Socket No. 50-315

FEB 16 1977

1. Amendment No. 18 to License No. DPR-58
2. Safety Evaluation
3. Notice

DONALD C. COOK NUCLEAR PLANT UNIT NO. 1

FIGURE 3.2-1 AXIAL FLUX DIFFERENCE LIMITS AS A FUNCTION OF RATED THERMAL POWER

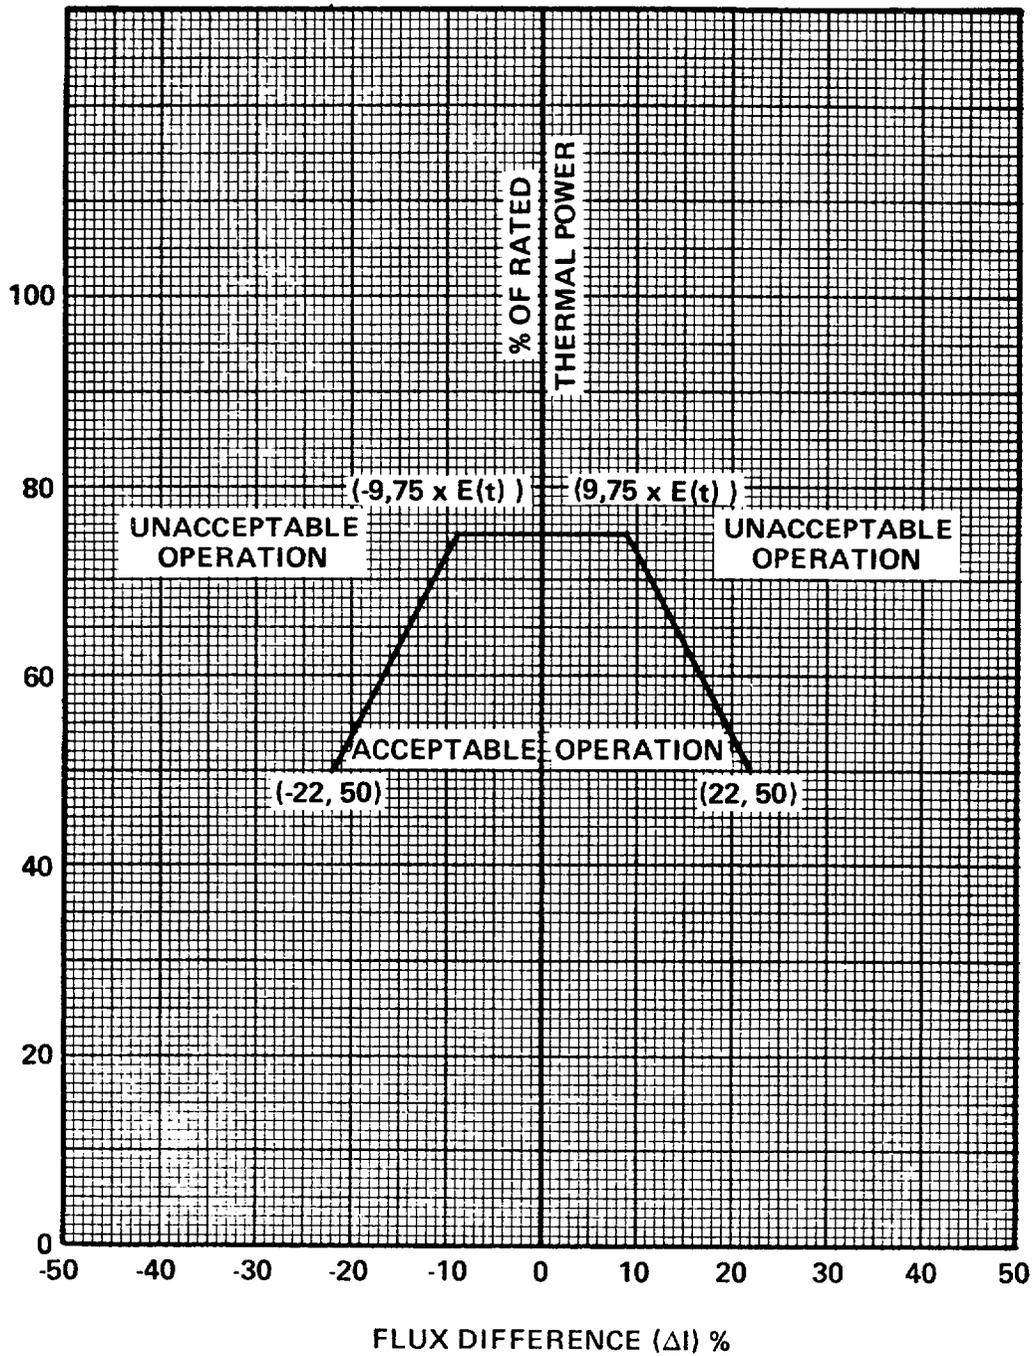
- 2) The indicated AFD is within the limits shown on Figure 3.2-1. Otherwise, reduce THERMAL POWER to less than 50% of RATED THERMAL POWER within 30 minutes and reduce the Power Range Neutron Flux-High Trip Setpoints to  $\leq 55\%$  of RATED THERMAL POWER within the next 4 hours.

- b) Surveillance testing of the Power Range Neutron Flux Channels may be performed pursuant to Specification 4.3.1.1.1 provided the indicated AFD is maintained within the limits of Figure 3.2-1. A total of 16 hours operation may be accumulated with the AFD outside of the target band during this testing without penalty deviation.

Figure 3.2-3 E(t) Normalized Core Power as a Function of Cycle Burnup

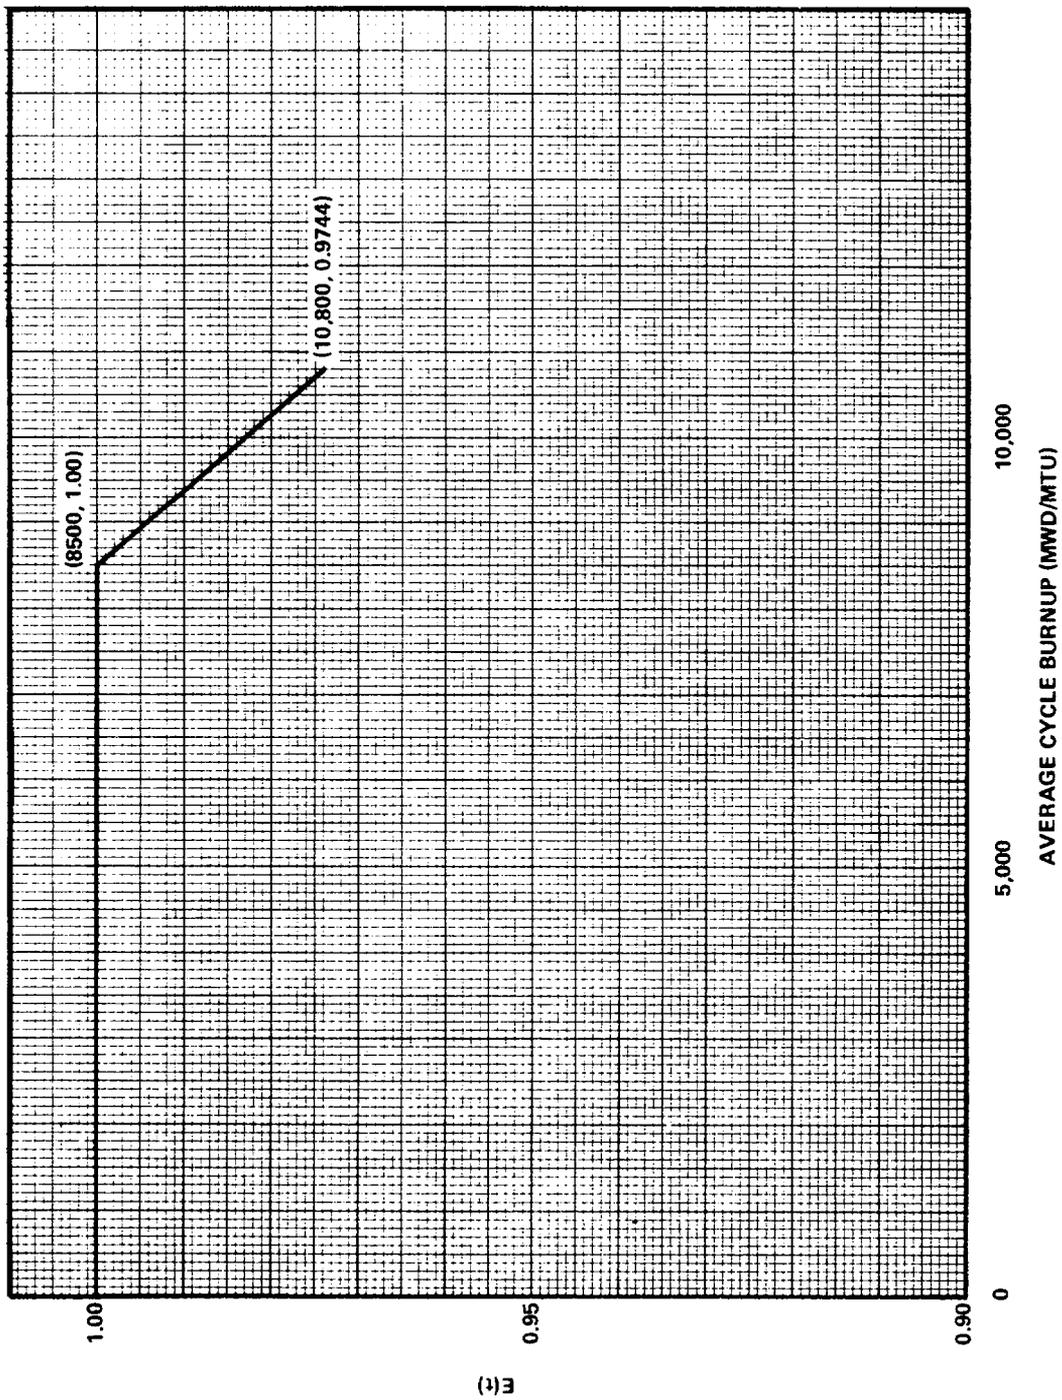
The limit on axial power distribution ensures that  $F_0$  will be controlled and monitored on a more exact basis through use of the APDMS when operating above 84% x E(t) of RATED THERMAL POWER. This additional limitation on  $F_0$  is necessary in order to provide assurance that peak clad temperatures will remain below the ECCS acceptance criteria limit of 2200°F in the event of a LOCA.

Figure 3.2-4 Target Axial Flux Difference at RATED THERMAL POWER as a Function of Cycle Burnup

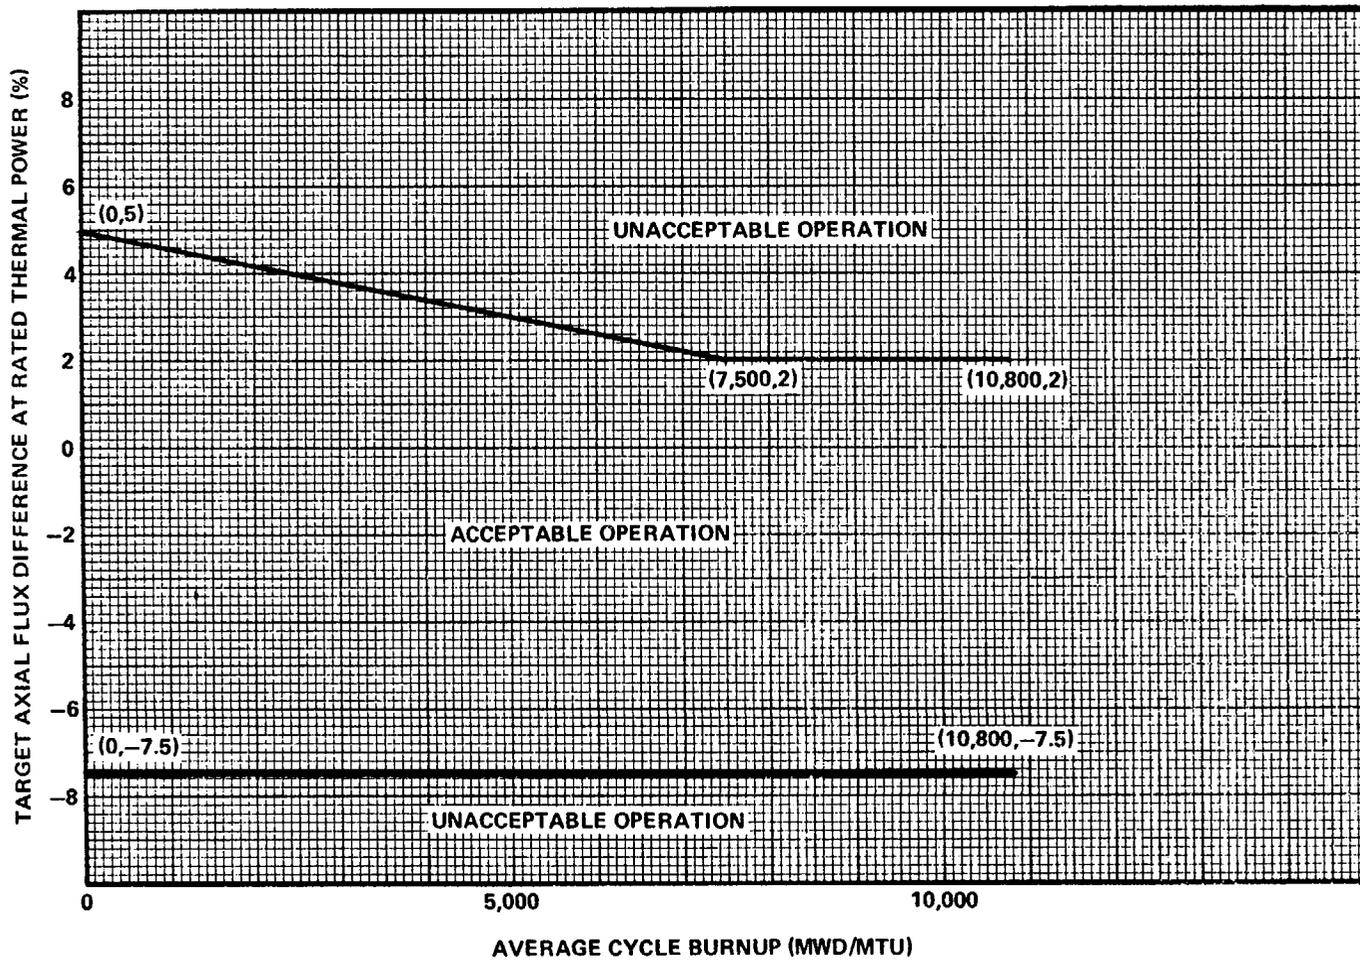
3.2.1 The indicated AXIAL FLUX DIFFERENCE (AFD) shall be maintained within a +5% target band (flux difference units) about the target flux difference shown on Figure 3.2-4.

FIGURE 2.1

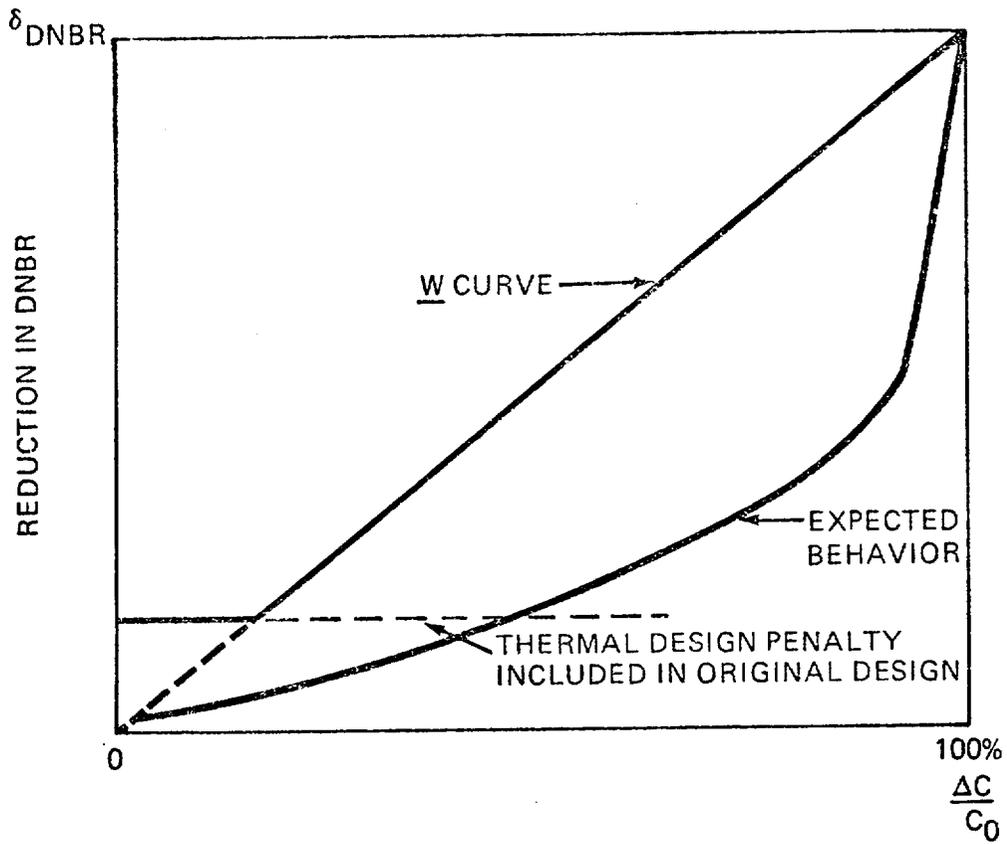
As stated in Section 2.1, data were presented by Westinghouse for the DNBR reduction at full contact and with no bow. No data at partial gap closure were presented. Westinghouse proposed, and the staff accepted, a straight line interpolation between these two points as shown in Figure 2.1.

This approach is conservative if the DNBR reduction does not increase more rapidly than the straight line reduction shown in Figure 2.1. Although the data for DNBR reduction due to rod bowing in the presence of an unheated fuel rod cannot be predicted by existing analytical methods, one would nevertheless expect that the actual behavior would more nearly follow the curved line also shown in Figure 2.1. According to this curved line, the DNBR would be reduced gradually for small amounts of bow. As the fuel rods (or fuel rod and unheated rod) become close enough so that there is an interaction, the DNBR would decrease more rapidly. No physical mechanism has been postulated which would lead to sudden large decreases in the DNBR for small or moderate gap closures. Thus, the straight line approximation is believed to be an overestimate of the expected behavior.

In developing the interim rod bow penalties described in this report, it became apparent that the penalty should be a function of burnup since the magnitude of rod bow is a function of burnup. However, to maintain existing thermal margins early in core life when only a small amount of fuel rod bow is anticipated, the initial pitch reduction factor was included until such time as the rod bow DNBR reduction became greater. This is represented as the straight horizontal line on Figure 2.1.

FIGURE 2.2

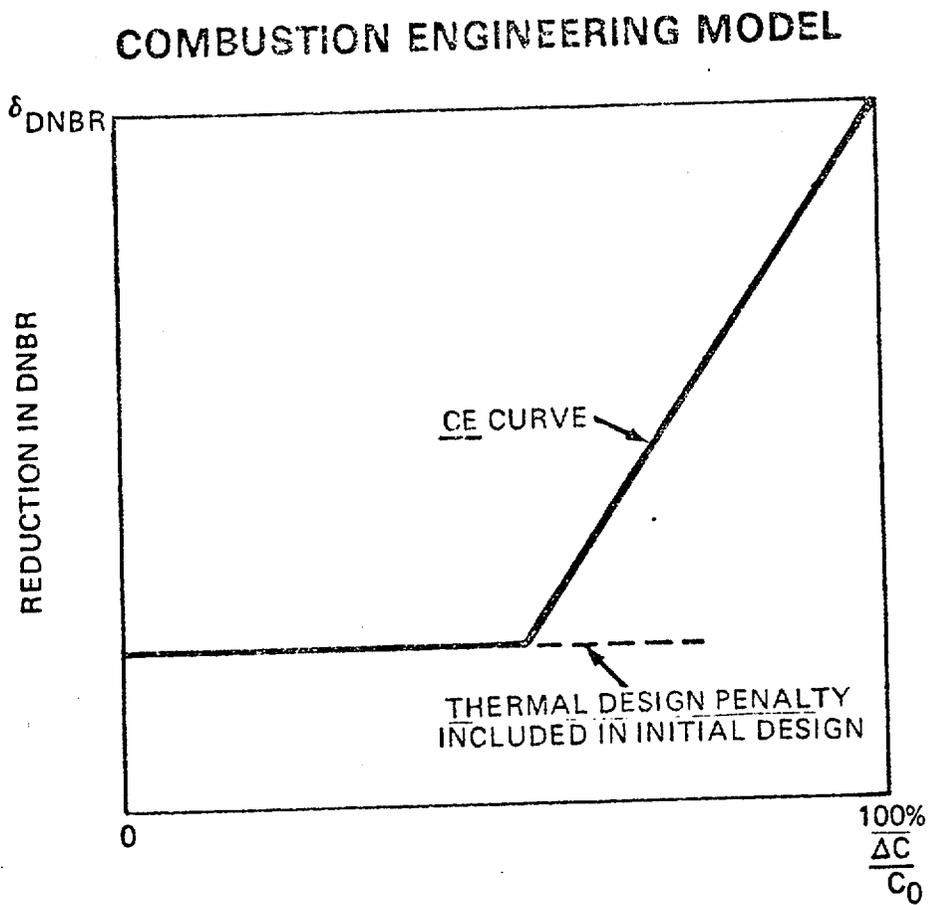
It should be noted that this behavior (little or no reduction in DNBR for small amount of bowing) is shown by Combustion Engineering data which became available to the staff after the Westinghouse model was derived. The Combustion Engineering data is discussed in Section 2.3 and the model derived from this data is shown in Figure 2.2.

in Figure 2.2. The horizontal straight line, representing the initial pitch reduction factor is included as explained previously in Section 2.2
